***MODIFICATION REQUEST:  
7 Railway Street, Chatswood  
MP09\_0154 MOD 1***

Director-General's  
Environmental Assessment Report  
Section 75W of the  
*Environmental Planning and Assessment Act 1979*

April 2012

**Figure 4: Proposed traffic signal system within the basement (Source: Proponent's Modification Request)**

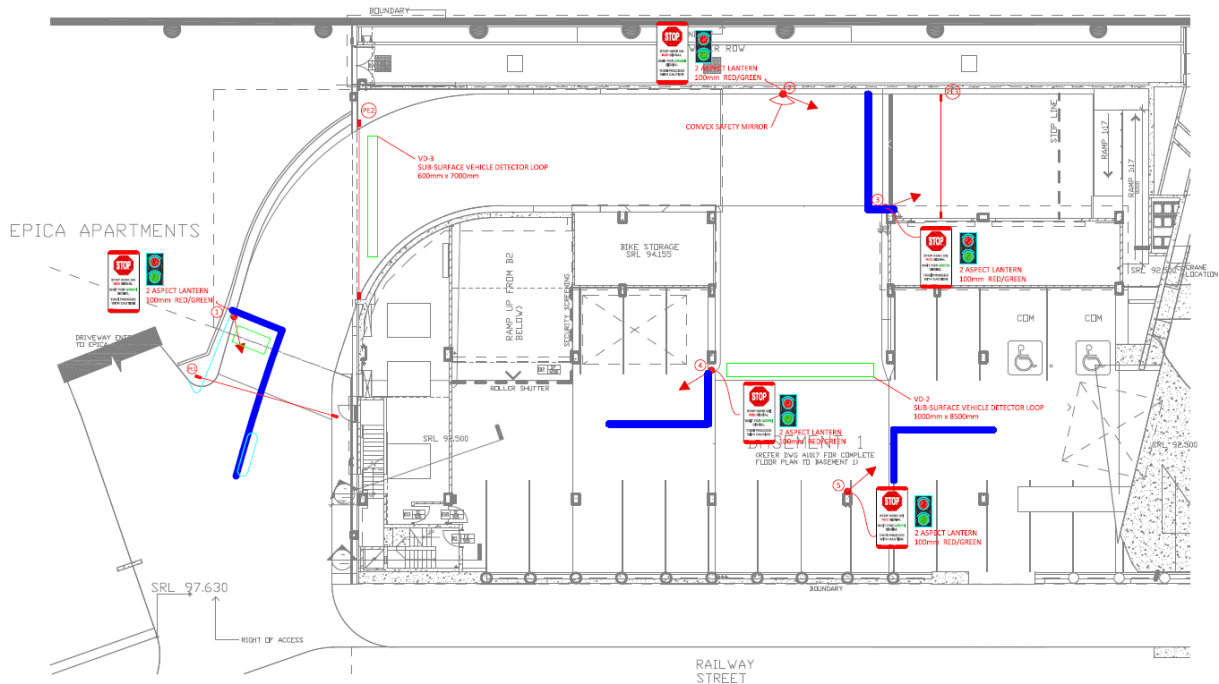
It is proposed to manage potential conflicts between reversing trucks and cars through a traffic signal system. The traffic signal system will operate at all times and involve detector loops and height sensors which will detect when a truck is entering and exiting the loading area. The proposed traffic signal system is shown in **Figure 4**.

Council objects to any amendment to the existing condition and considers that the provision of an additional half basement level should be provided so that the delivery/waste collection does not conflict with cars using the car park.

RMS originally raised objection to the proposed amendments and considered that the proponent did not adequately demonstrate how the conflict between trucks and cars will be addressed and the measures put in place to ensure that access and safety to the car parking access is not compromised.

After a meeting with the proponent and consideration of additional information on how the conflict between trucks and cars would be managed, RMS advised that they raised no objection to the proposed traffic signal system to manage truck and car access to the car park.

The Department is satisfied that the proposed traffic signal system, as agreed to by RMS, will ensure that both trucks and cars can safely access the site. The traffic signals will ensure that the potential conflict between reversing trucks and cars is removed.

On this basis, the Department supports the proposed traffic signal system to remove the potential conflict between trucks and cars. It is therefore recommended that Condition B2(g) be amended to delete the requirement for separate manoeuvring space and require the implementation of the proposed traffic signal system instead.

**Figure 5: Existing Services in Railway Street and the zone required for tree planting (Source: Proponent's Modification Request)**

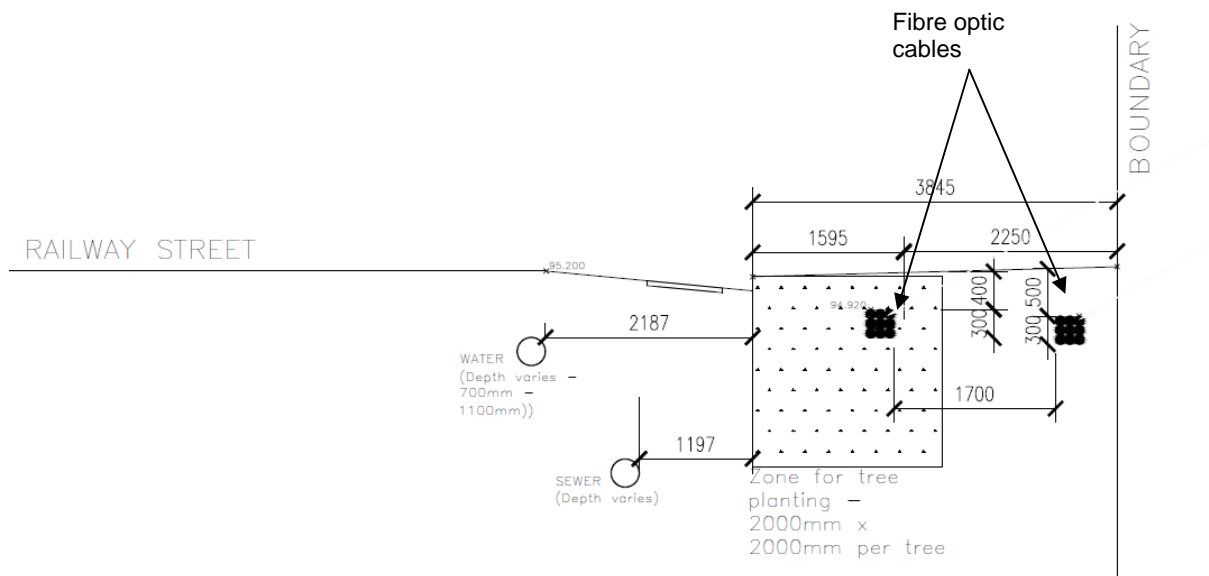
The proponent has advised that major Telstra fibre optic cables (running between Sydney and Brisbane) are located under the footpath on the eastern side of Railway Street. The proposed tree root zone would therefore interfere with these existing cables (refer to **Figure 5**). The relocation of this cable is not feasible due to the disruption to services (an estimated cost of \$1 million per day) which would result and the conflict with other services.

Council considers that the street trees are an essential element within the Chatswood CBD to enhance the public footpath, provide shade and rain cover, mitigate wind impacts and soften the scale of buildings for pedestrians. Council considers that the services located within the footpath can be relocated.

The Department supports the proposed alternate planting within the property boundary given the difficulty and cost (estimated at \$1 million lost revenue per day) associated with the relocation of the major Telstra fibre optic cables. The tree planting within planters is also consistent with the landscape character established for Railway Street (refer to **Figure 7** above). The wind impacts associated with the deletion of street trees are discussed in **Section 5.4**.

On this basis, it is recommended that Condition E17 be deleted, subject to the revised landscape plan featuring additional trees within the property boundary being approved as part of Condition A2.

**Figure 6: Proposed Landscape Plan with trees proposed along the western portion of the Railway Street frontage within the publicly accessible open space (Source: Proponent's Modification Request).**

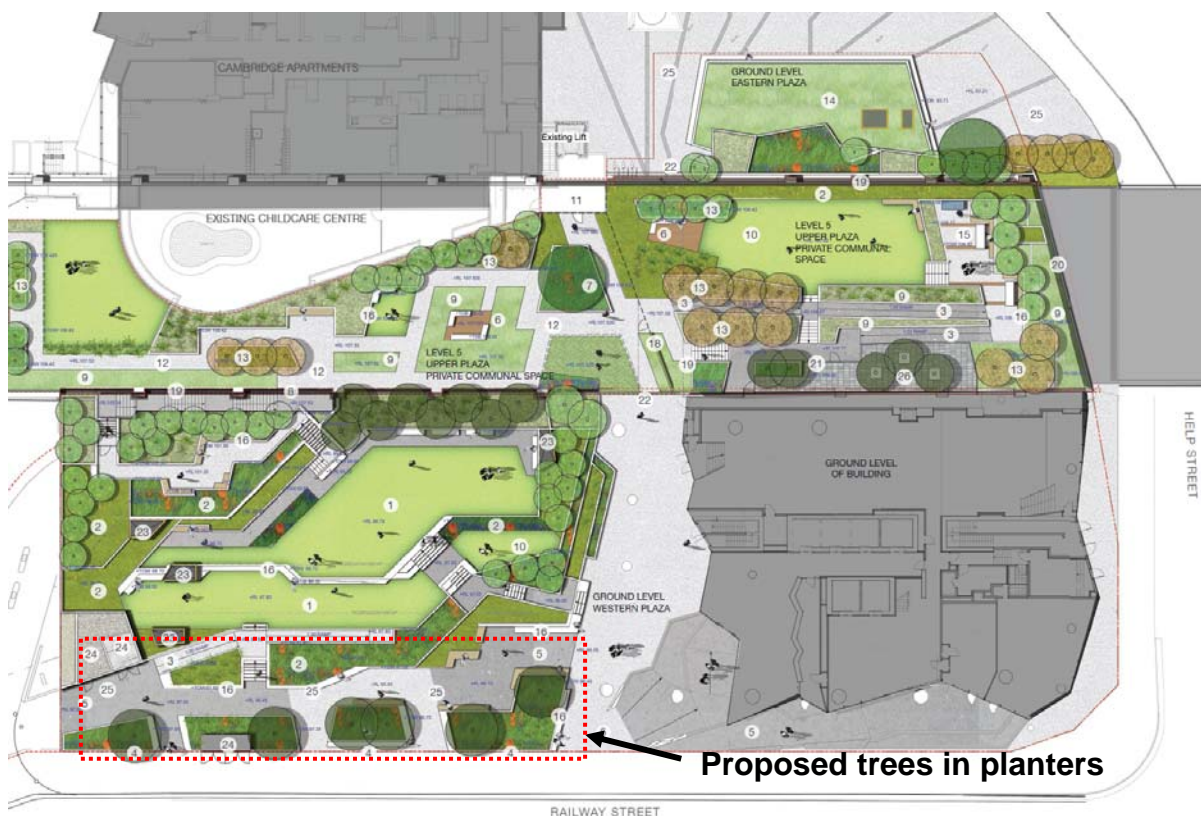
The proponent proposes to delete the street trees and provide replacement trees within the boundary in planters along the western portion of the Railway Street frontage. Refer to **Figure 6**.

**Figure 8:** Wind testing locations and with possible pedestrian routes shown in blue  
(Base Image Source: Proponent's Modification Request)

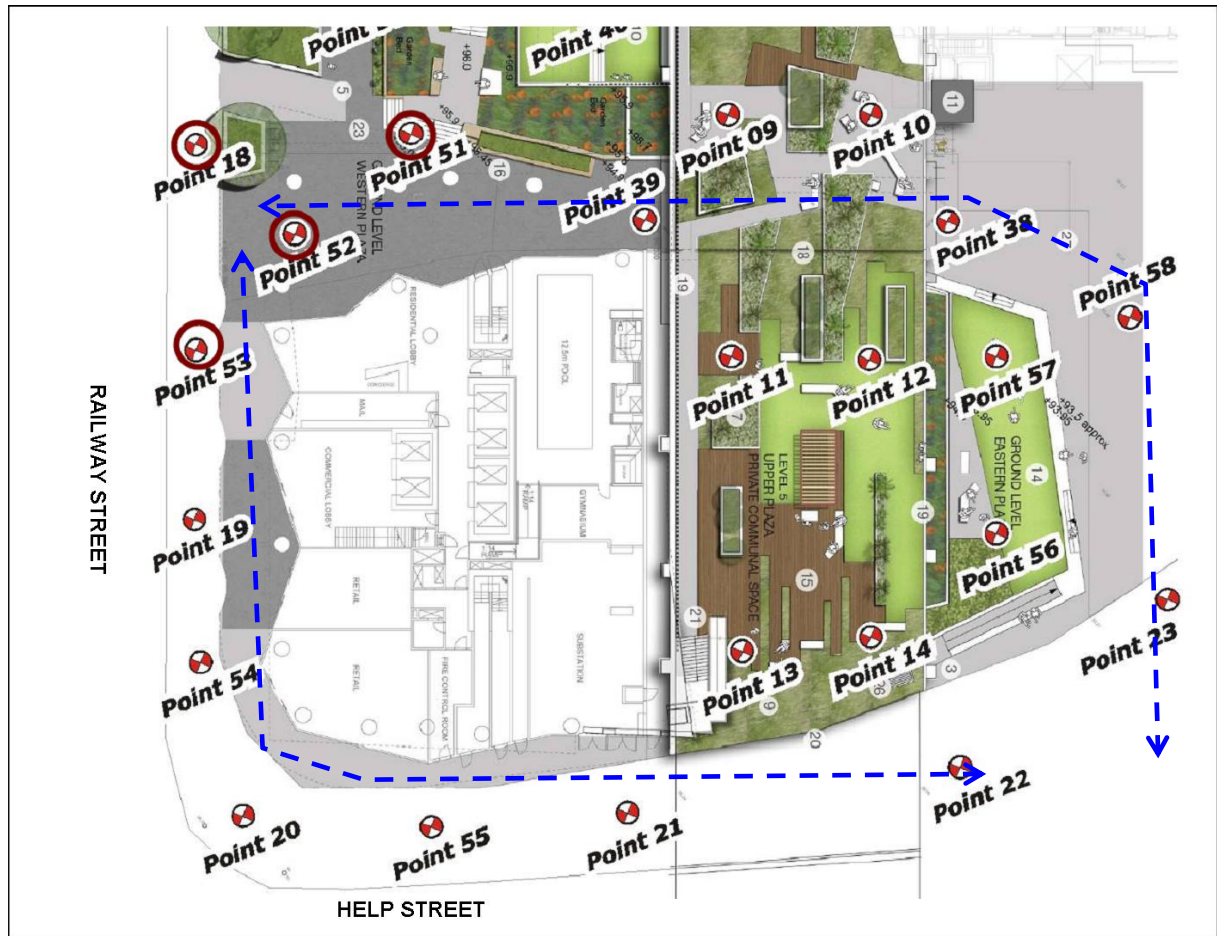
It is noted that existing wind conditions at an isolated location on the corner of Railway and Help Street (refer to Point 20 in **Figure 8**) comply with the Lawson slow walking criteria of 8m/s but exceed the Davenport slow walking criteria of 7.5m/s by 0.4m/s.

In the absence of street trees, the post development wind conditions in this location are estimated to be 7.8m/s. This is an improvement to the current conditions and continues to comply with the Lawson criteria. The wind conditions, however will not meet the more stringent Davenport criteria for slow walking.

In addition, the annual maximum gust (a sustained gust of wind for a period of 3 seconds once per year) at Point 20 is 24.6m/s which also exceeds the Melbourne criteria by 1.6m/s. The proponent's wind engineer has advised that this gust speed in a small area presents an acceptable level of risk, noting that the difference between a 3 second gust of 23m/s and 24m/s is not significant.

- the exceedance is limited to an isolated location being a very small area at the corner of Railway and Help Street;
- the proponent's wind engineer has also advised that the wind conditions in the areas surrounding Point 20 comply with both the Davenport and Lawson slow walking criteria (locations 19, 54, 55 and 21 in **Figure 8**);

- the maximum gust of 24.6m/s in this location is expected to occur for only 3 seconds once a year and in this regard is unlikely to significantly impact on pedestrian safety and amenity; and
- while the area will be used for pedestrians wishing to cross Railway Street, pedestrian routes are also provided:
  - under the awning of the building which generally aligns with the property boundary; and
  - through the landscaped open space and tunnel as shown in (refer to **Figure 8**).

On this basis, the deletion of the requirement for street trees (Condition E17) is considered acceptable with replacement trees provided within the property boundary.
